Subject: Certificate of Compliance No. 5862; Docket No. 71-5862

This submittal is in response to your letter FCTC:CEW 71-5862 dated July 25, 1985 with an enclosure entitled "Teledyne Energy Systems, Model No. Sentinel 100F, Docket No. 71-5862 dated July 25, 1985."

STRUCTURAL AND THERMAL  
EVALUATION  
OF SENTINEL 100F

INSD-3080

FIGURE E.1. RTG TO PALLET MOUNTING HARDWARE

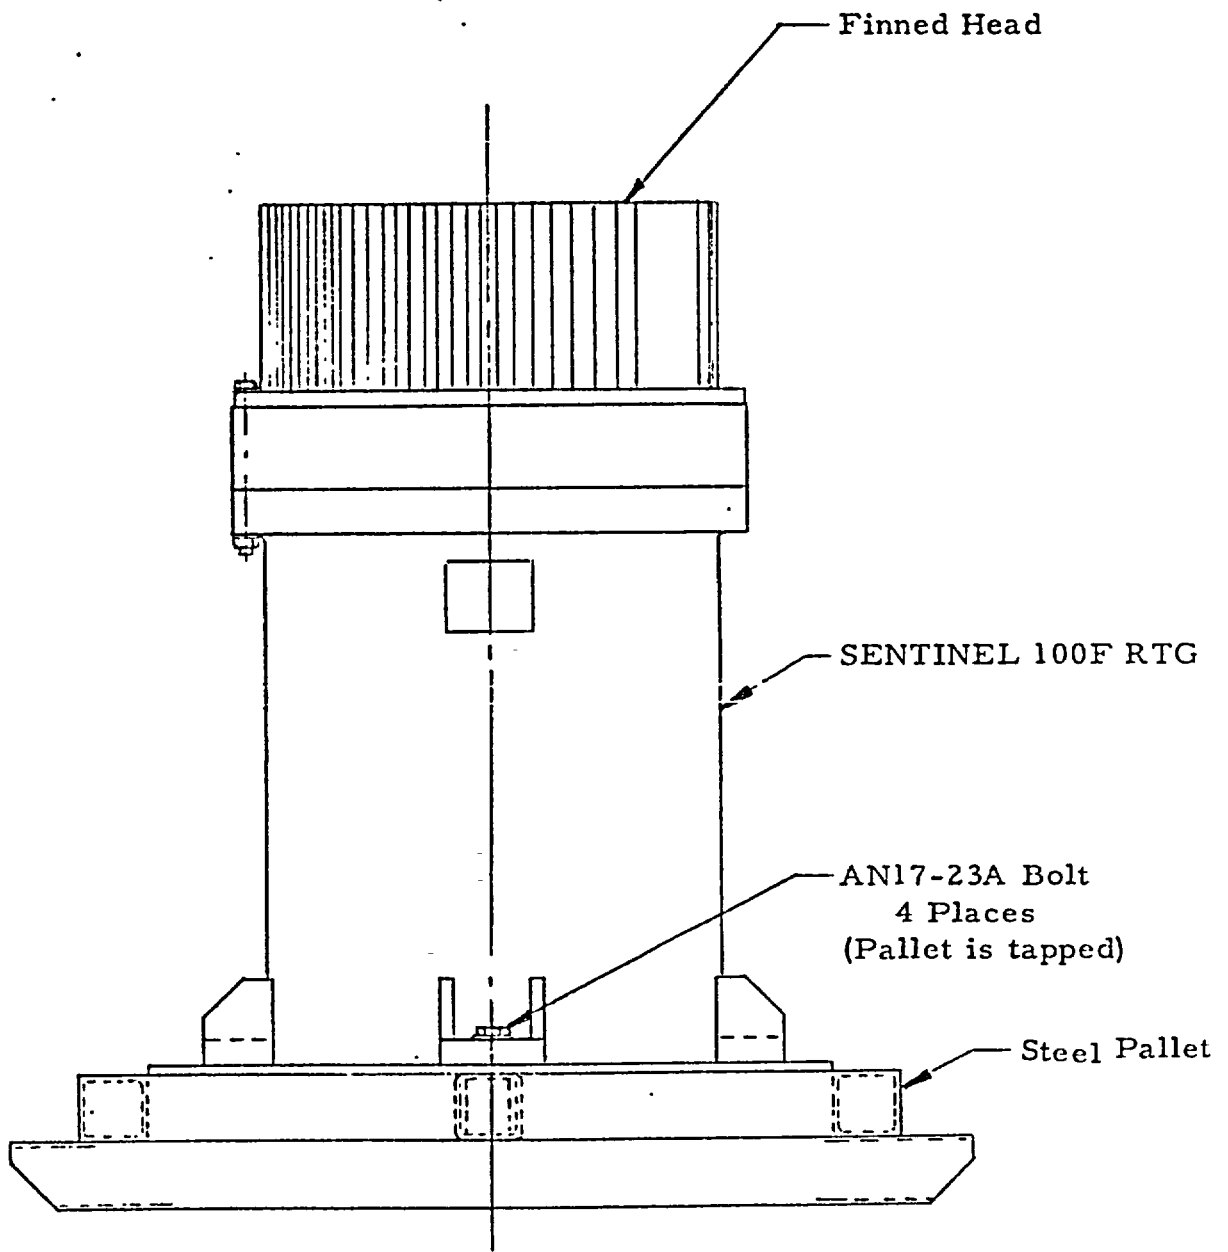
Item 1 of the enclosure requested a discussion of the procedures for preparation of the package for shipment specific to the requirements of 10CFR71.87. Appendix E of the revision addresses the requirements of both 71.85 and 71.87.

The procedures described herein pertaining to the RTG housing and pallet were applied during the construction phase of the unit with the intent of assuring a sealed unit with adequate structural integrity. (The RTG housing, bolted to a steel pallet assembly comprises the transportation package.) Section E.1 (below) addresses the specific requirements of 71.85.

The RTG is bolted to a steel pallet assembly for shipment using the hardware shown in Figure E.1. Hardware is torqued to  $300 \pm 30$  foot pounds.
